MODEL
2018-2019
Niro (PHEV, EV)

NUMBER
202

TECHNICAL SERVICE BULLETIN

SUBJECT: **SERVICE ACTION: IN-CABLE CONTROL BOX
PROTECTION COVER INSTALLATION (SA425)**

Installation Procedure:

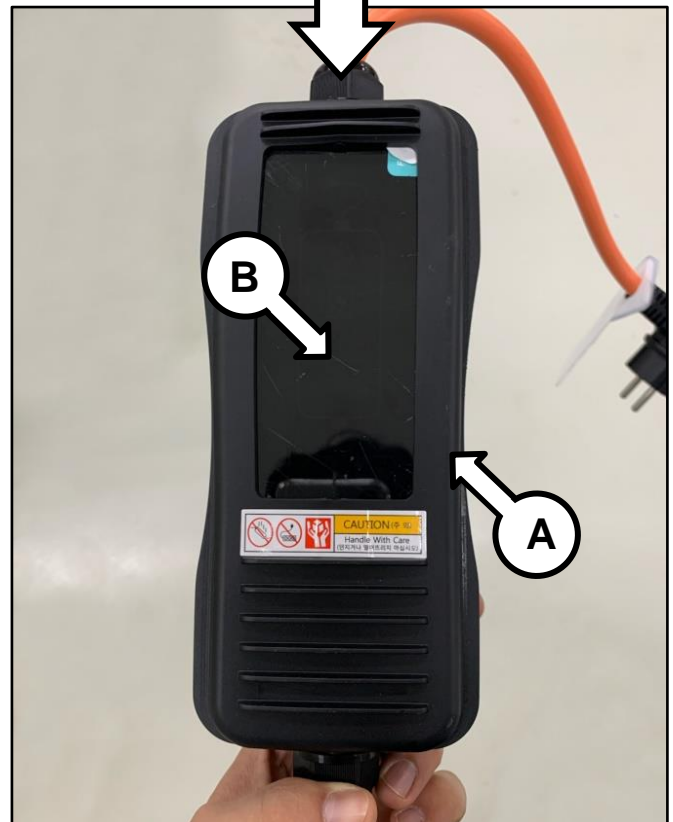
This bulletin provides information on the installation of the In-Cable Control Box (ICCB) / Level 1 Charge Cord protection cover on some Niro (PHEV/EV) vehicles listed below, in order to protect the ICCB from impact which can easily cause damage. Before conducting the procedure, verify the vehicle is included in the list of affected VINs.

1. Pull the inner bottom side openings outward from the ICCB protection cover (A).

2. Insert the ICCB device (B) into the protection cover (A) as shown.
